I object to the whole of the WestConnex Project, and the specific WestConnex M4-M5 Link proposals as contained in the EIS application, for the following reasons, and request the Minister reject the application.

<p>Attention Director Application Number: SSI 7485</p> <p>Infrastructure Projects, Planning Services, Department of Planning and Environment GPO Box 39, Sydney, NSW, 2001</p> <p>Application Name: WestConnex M4-M5 Link</p>	<p>Name: Joshua Southgate</p> <p>Signature: </p> <p>Please <u>include</u> my personal information when publishing this submission to your website. I <u>HAVE NOT</u> made reportable political donations in the last 2 years.</p> <p>Address: 3 Leonora Ct</p> <p>Suburb: Hornsby Hts Postcode 2077</p>
---	--

The EIS states in 6.5.8 Darley Road civil and tunnel site (C4) that:

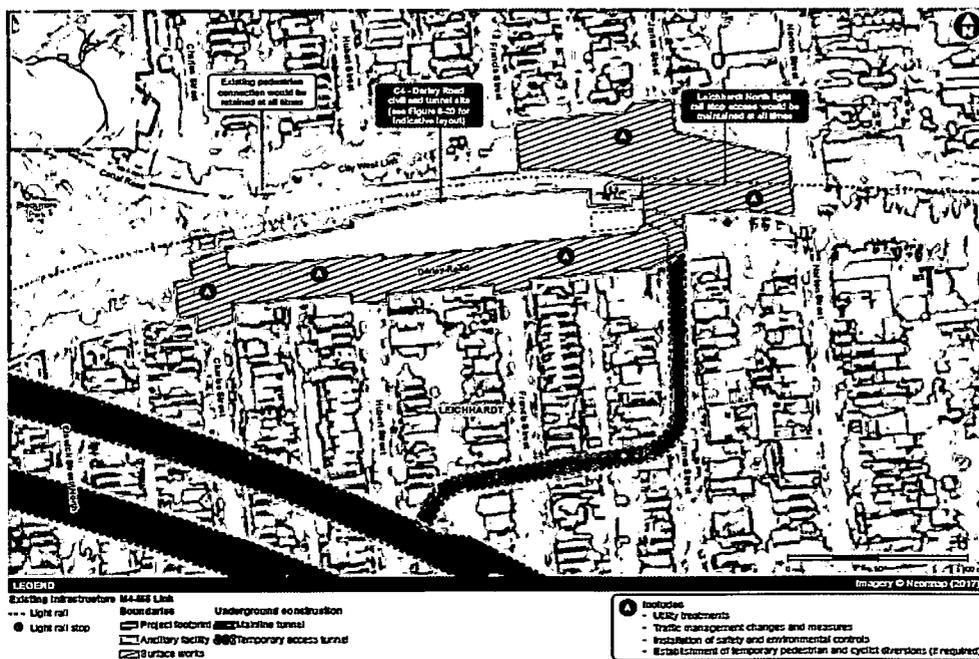
It is not clear how continued access, pedestrian and cyclist movement will be preserved and I am concerned that the impacts have not been correctly identified and

assessed by the proponent.

Cumulative impacts of aircraft noise and construction noise

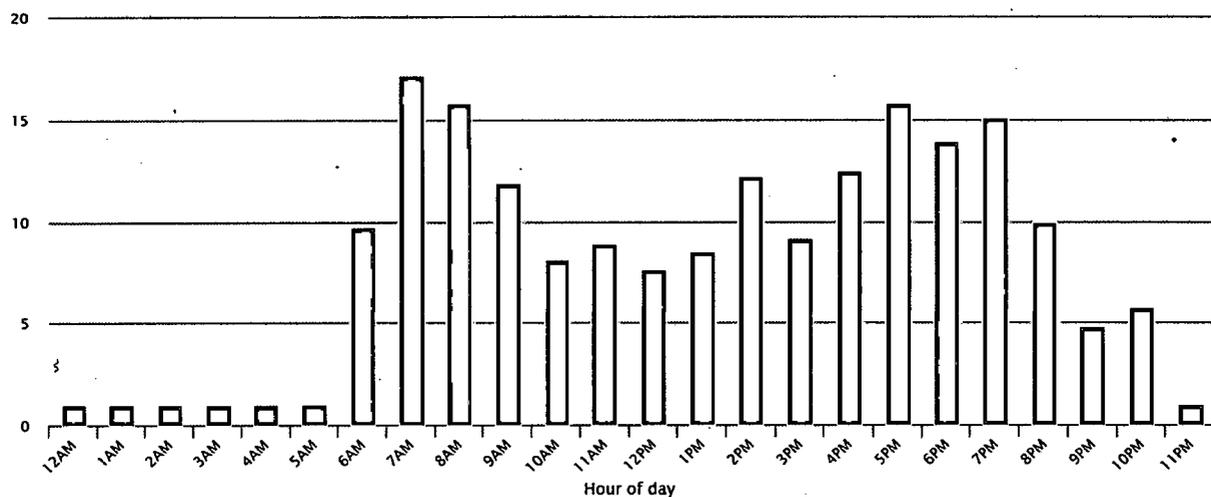
- I object to the EIS because the proponent has failed to take account of the cumulative impact of its proposed Darley Road, Leichhardt civil and tunnel site operations and the aircraft noise which the residents near the site already endure.

The attached extract from Webtrak shows that Darley Road, Leichhardt and adjacent streets are directly under the flight path. Airservices Australia reports that in April to June 2017 the number of average daily noise events over 70 dBA. In Leichhardt this is an average of 16- 17 per hour over the peak morning period and 16 per hour in the early evening peak period.
